**Subject:** For BOTH Redtail Ranch and Flying Horse North Preliminary Plans and Respective Plats

*Regarding the definition of what is needed for Principal Arterial in MTCP and ECM and inconsistencies among PUD Rezone approvals for Flying Horse North (Black Forest Road) in 2016, Retreat at Timber Ridge on 3-27-2018 (Vollmer Road) and the current Draft Preliminary Plan for Redtail Ranch (March 2018).*

For: Redtail Ranch Adjacent Landowner comment - August 28, 2018  
Preliminary Plan and Final Plat  
re: Drainage - spillway for Stock Pond Design Point D2 on Lot 3, Kettle Creek Basin  
Preliminary/Final Drainage Report for Redtail Ranch Filing 1 July 2018  
for Michael Ludwig by Marc Whorton PE - Classic Engineering

FHN Final Plat - Addl documents # 7ef70a64-c9aa-422b-8047-65512cf1d5aa on [www.devplanrview.com](http://www.devplanrview.com) from 8/3/2018

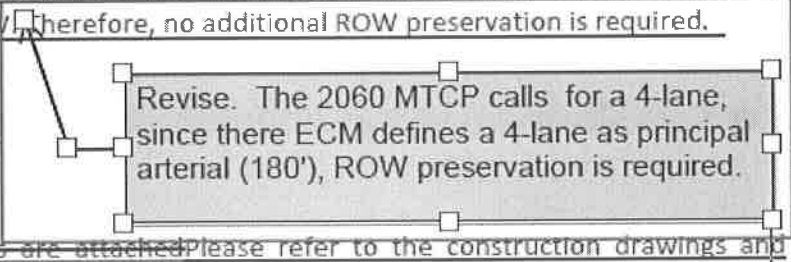
The MTCP 2060 Corridor Preservation Plan show Black Forest Road as a four-lane Minor Arterial adjacent to the site. ~~DO THEY NEED TO DEDICATE ADDITIONAL ROW???~~ Per ECM Tables 2-4 and 2-6, the ROW for a two-lane Minor Arterial (Rural) is the same as for a four-lane Minor Arterial (Urban) – both are 100-foot ROW, therefore, no additional ROW preservation is required.

Revise. The 2060 MTCP calls for a 4-lane, since there ECM defines a 4-lane as principal arterial (180'), ROW preservation is required.

FHN Final Plat - Addl documents # 7ef70a64-c9aa-422b-8047-65512cf1d5aa on [www.devplanview.com](http://www.devplanview.com) from 8/3/2018

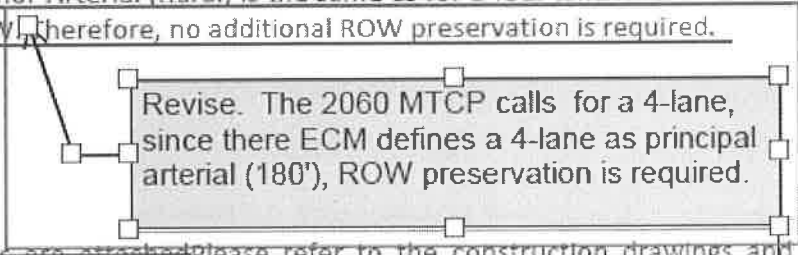
The MTCP 2060 Corridor Preservation Plan show Black Forest Road as a four-lane Minor Arterial adjacent to the site. ~~DO THEY NEED TO DEDICATE ADDITIONAL ROW???~~ Per ECM Tables 2-4 and 2-6, the ROW for a two-lane Minor Arterial (Rural) is the same as for a four-lane Minor Arterial (Urban) – both are 100-foot ROW, therefore, no additional ROW preservation is required.

Aug 2008 pond full - looking  
SSW - after overtopping

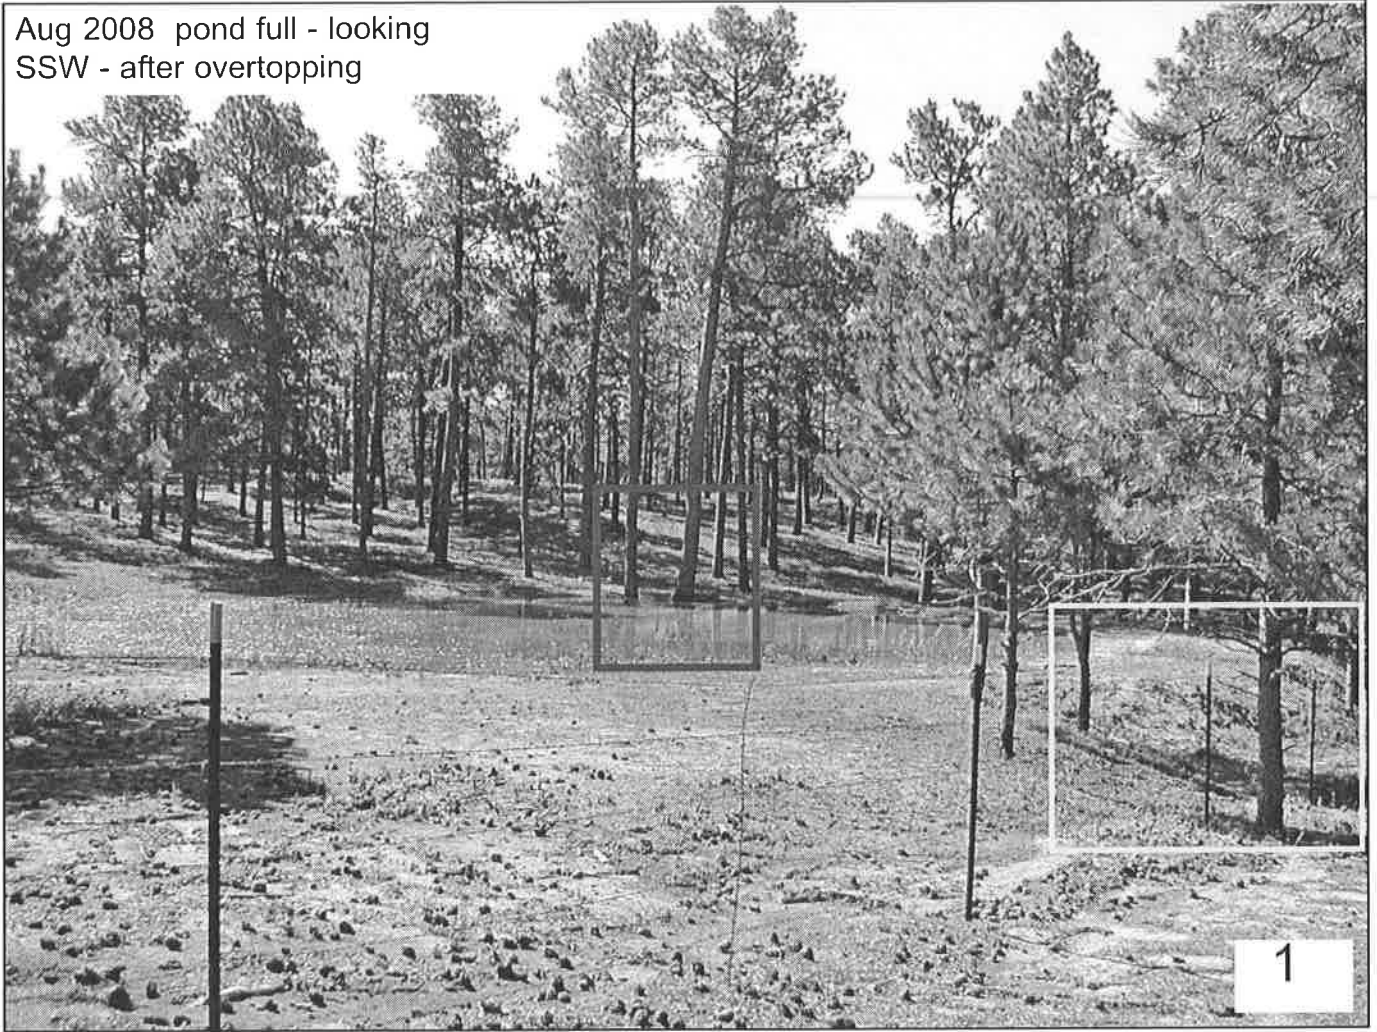
When we had a wet summer and strong storms in 2008 the pond was overflowed the dam (see photos taken just after the event and beginnings of dam erosion). I spoke to Munson about putting in a spillway. He refused and I informed him that he was putting my property at risk.

I am attaching photos from 2008 when the land was rather denuded from grazing and the pond full and overtopping the dam. If a proper spillway had been in place, this overtopping, and start of headcutting would not have happened.

I am requesting here that Mr. Ludwig put in a proper spillway on the south side of the pond, with a riprap base for flash-flood events. There is grass present, but the gradient is short and steep to the property line and I believe it should have some rocks to attenuate the flow and protect the surface on the Redtail Ranch property. this drainage problem and liability should not be passed on to a new landowner for Lot 3.

I am asking that a proper spillway be constructed to the left (east) of the trees with a riprap channel to maintain the pond surface below the tree level and far enough below the dam to safely accommodate water from heavy precipitation events like the one in August of 2008.

Aug 2008 pond full - looking S W  
over erosion after overtopping

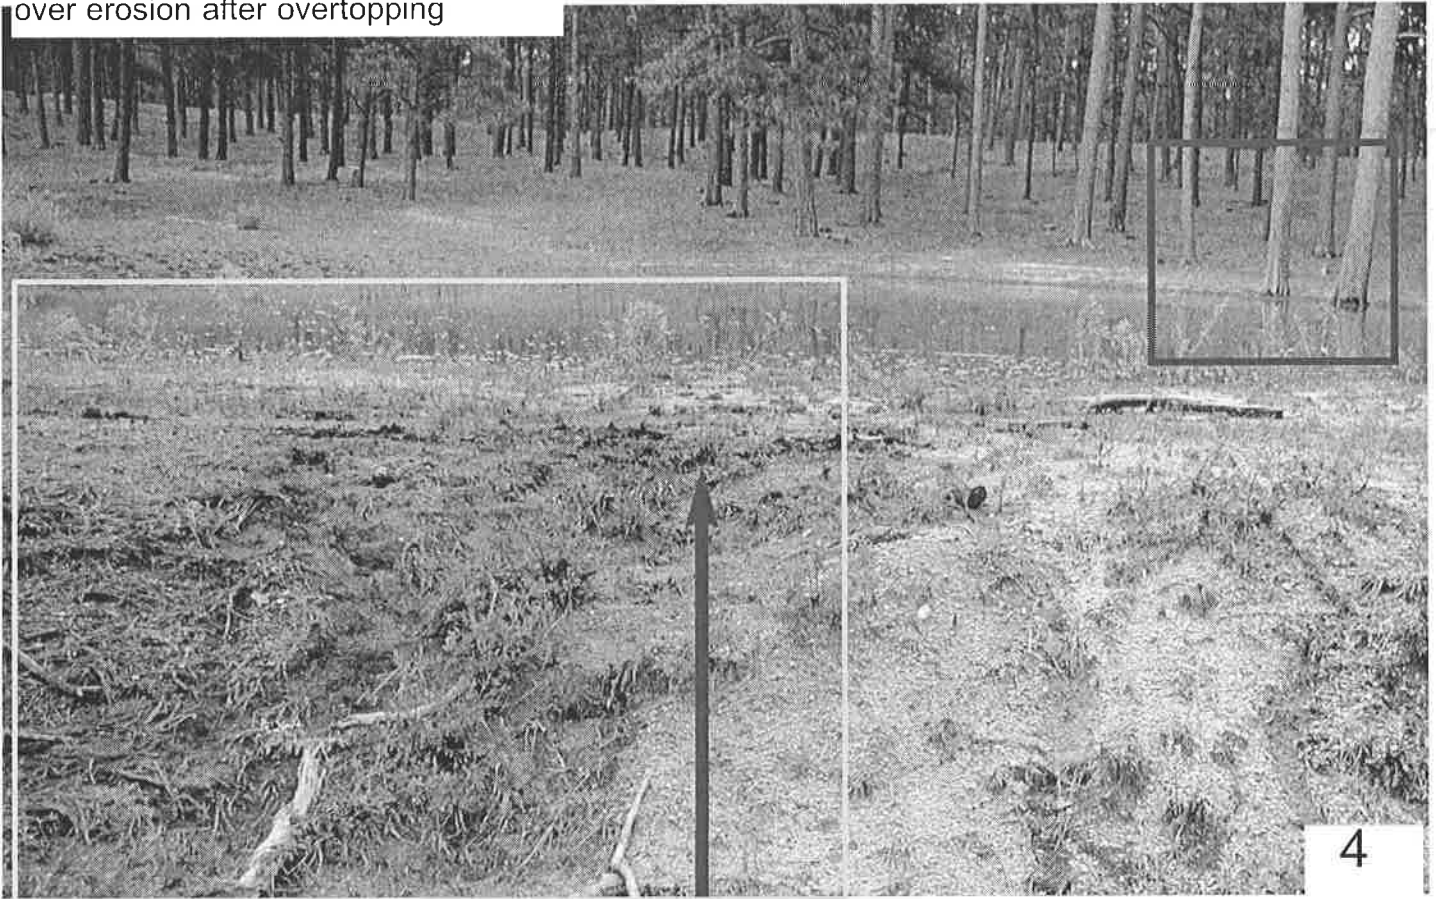
The yellow boxes show the bare area on the west side of the dam where overtopping water washed off litter and began to headcut.

Concept for Redtail Ranch local trail.

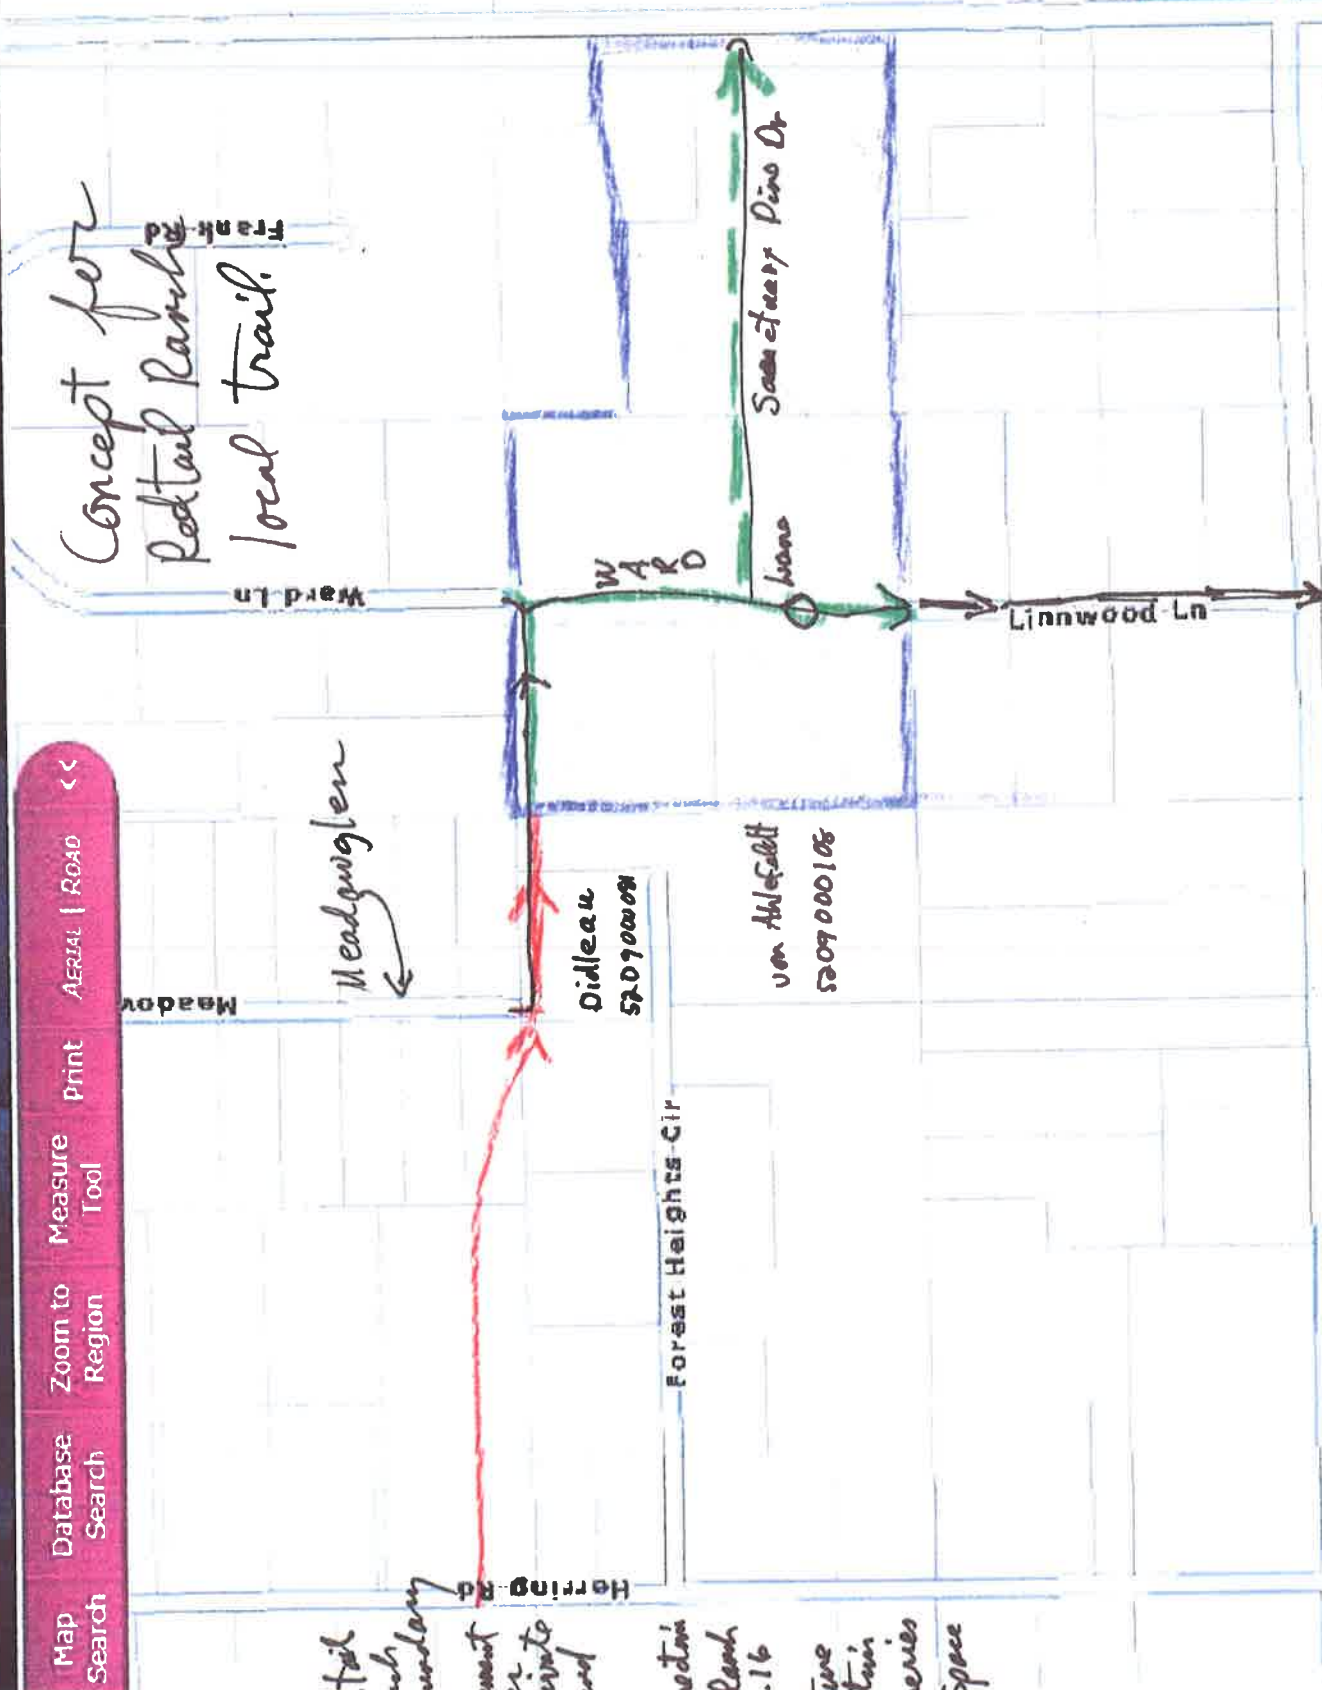
5. That Redtail Ranch include a multi-use, publically accessible non-motorized trail (in accordance with the *Black Forest Preservation Plan*) to connect existing trails. This can be expedited with assistance of the Black

Forest Trails Association, to provide an accessible network of trails using unpaved roads and access over private land. (See attached) I, and my neighbors Jon and Phyllis Didleau, are willing to provide connection to Redtail Ranch from the end of Meadow Glen Road. The Didleau's also have an existing trail connecting Meadow Glen Road to Forest Heights Circle (a private road with a public ROW) over their property. This would be part of the Black Forest Trails Association trail network system
